PRE-PRODUCTION FEEDBACK

Date: 23-12-2020
Revision: 1.0
Author: Tony Little
Product: Electric Skateboard
Company: Globe Brand

4.6.1 ERM SOLDERING

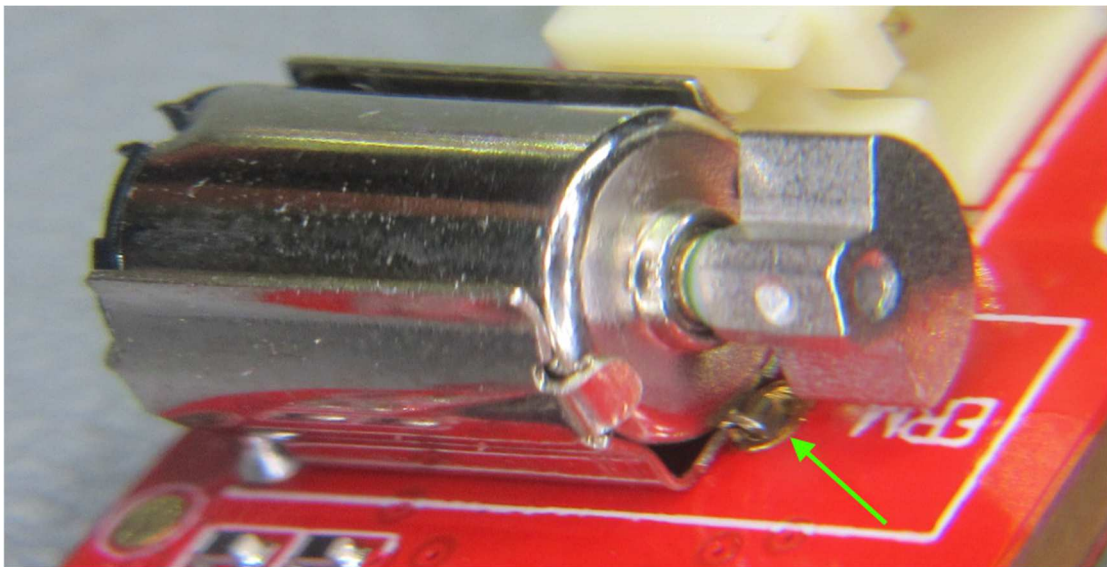
The soldering to the ERM frame pins is still insufficient. The PCB design was tweaked to provide more thermal relief and a greater opening. Those holes were changed to slot to improve solder flow. The likely soldering issue is more related to the short length of the pins, along with the high thermal bleed to the chassis.

The pins to the electrical connections have significantly less thermal bleed. The soldering is good, although one was borderline. Given production history, there should be no reliability concern given the ERMs are continued to be glued to the PCB.

4.6.2 WIRELESS MODULE ALIGNMENT

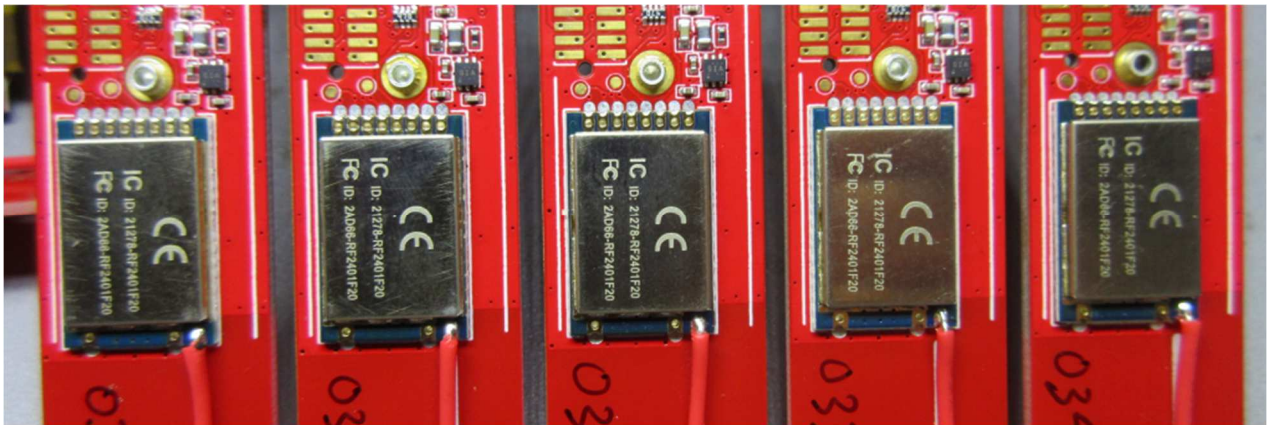
Reflowed alignment is good.

4.6.3 USB CONNECTOR ALIGNMENT

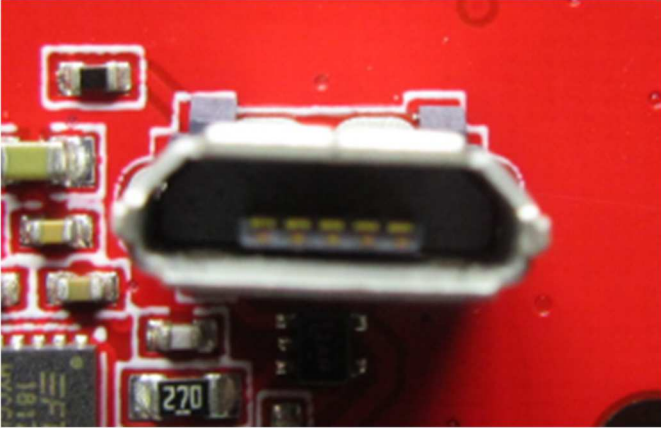
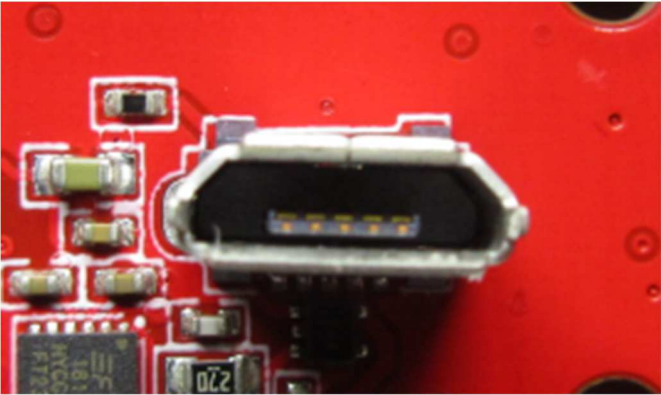
7 units had very good USB connector. The 3 below were not ideal.

Units FFFF030, FFFF02C (worst example), FFFF02D.

4.7.1 FFFFF02B

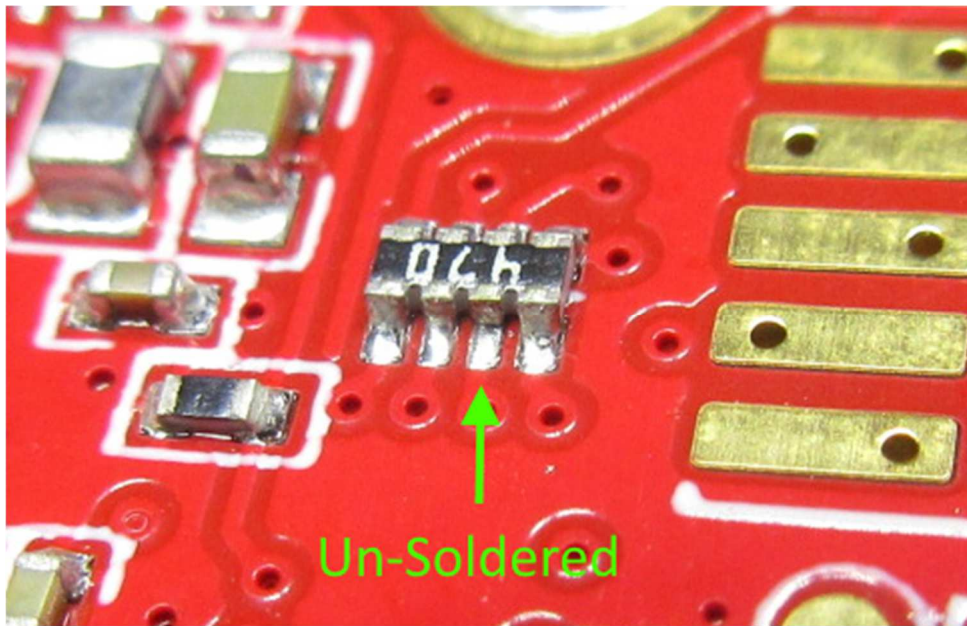
Wireless not functioning.

Found R25 with un-soldered contact.

4.7.2 FFFFF02E

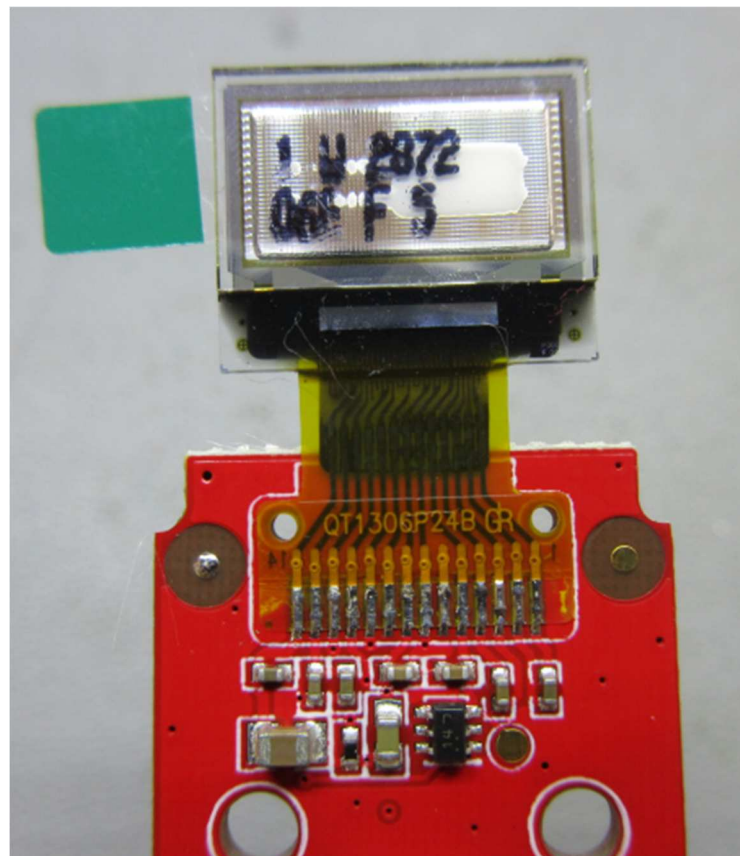
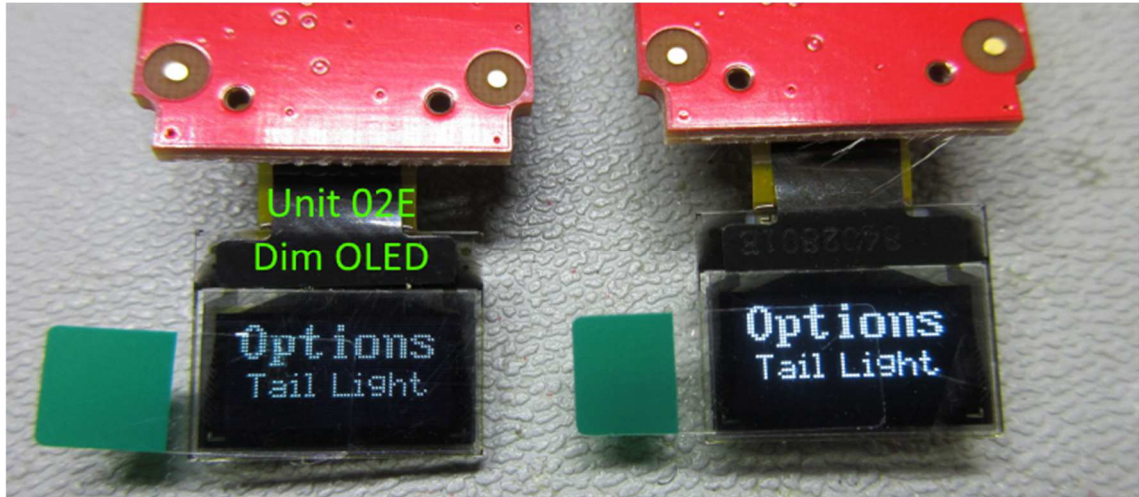
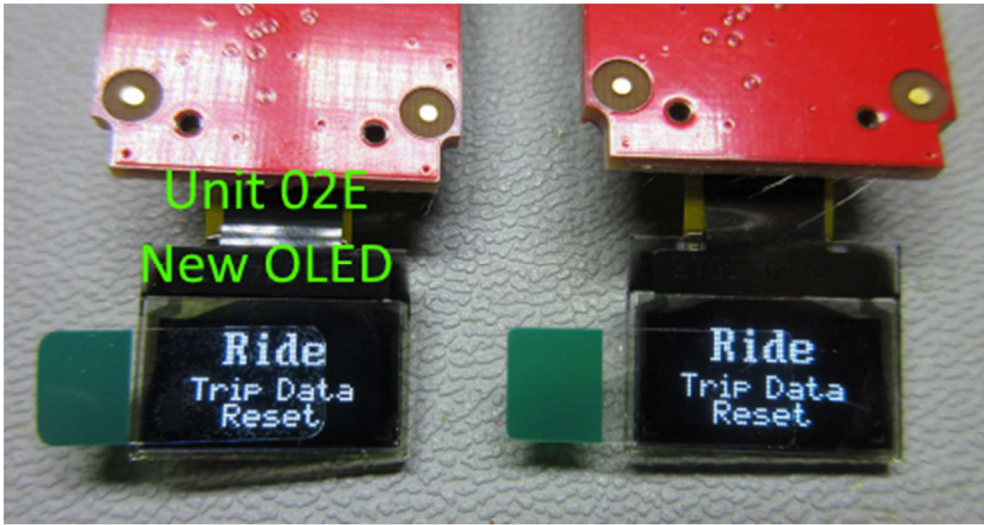
OLED Dim.

Replaced OLED. Brightness correct.

4.7.3 FFFFF030

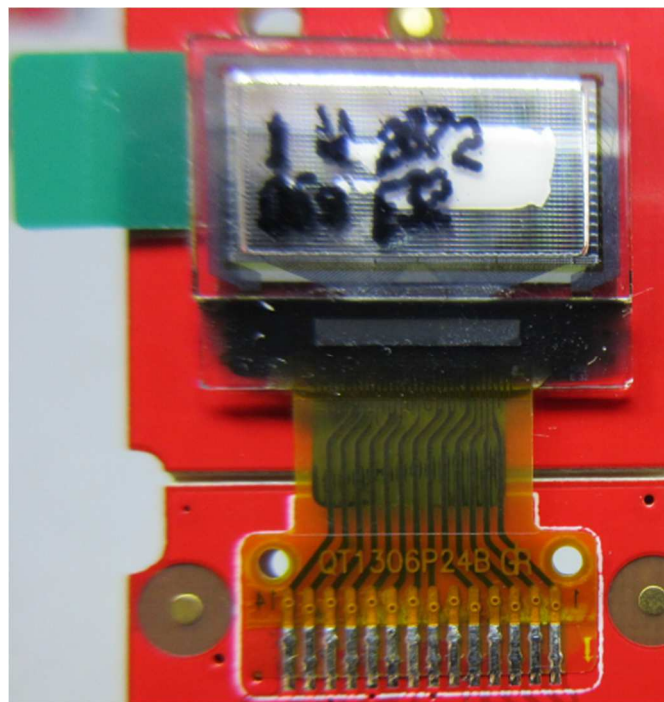
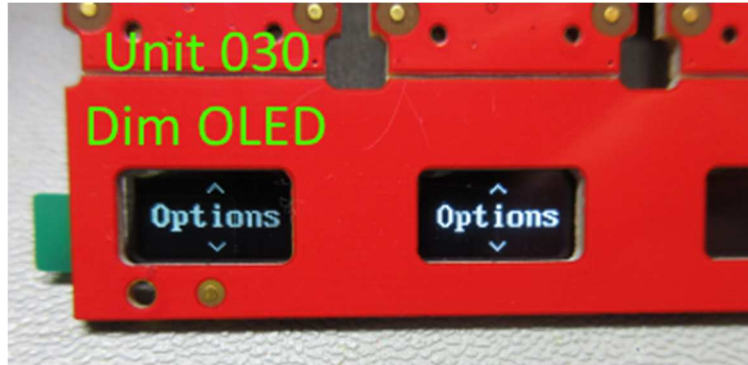
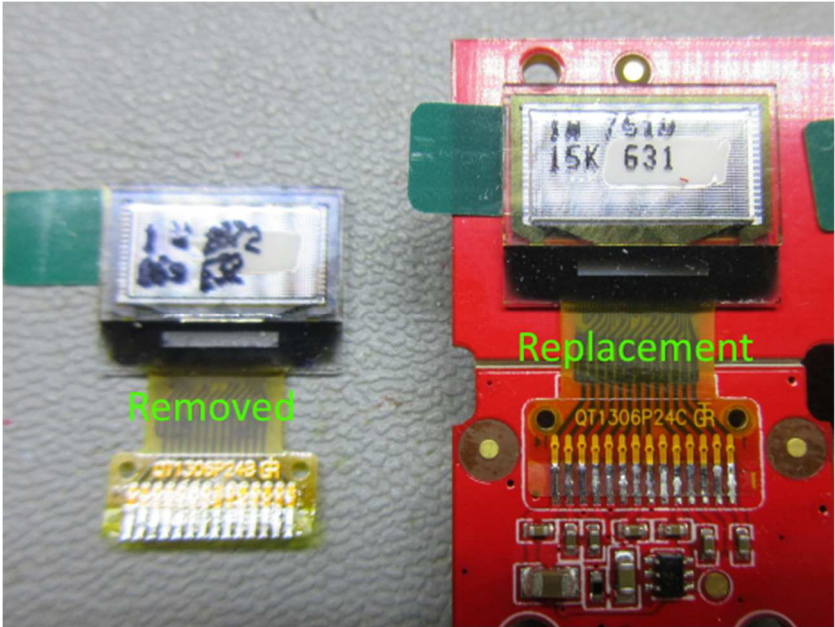
OLED is dim.

Re-soldered tab with flux. OLED is still dim.

Measurements

- VCOMH = 7.49V
- VOLED = 4.02V
- VDD = 2.498V
- C1 = 1.42V
- C2 = -4.45V
- IREF = 4.70V

Replaced OLED. Display brightness as expected.

- VCOMH = 7.49V
- C1 = 1.29V
- C2 = -4.58V
- IREF = 4.68V
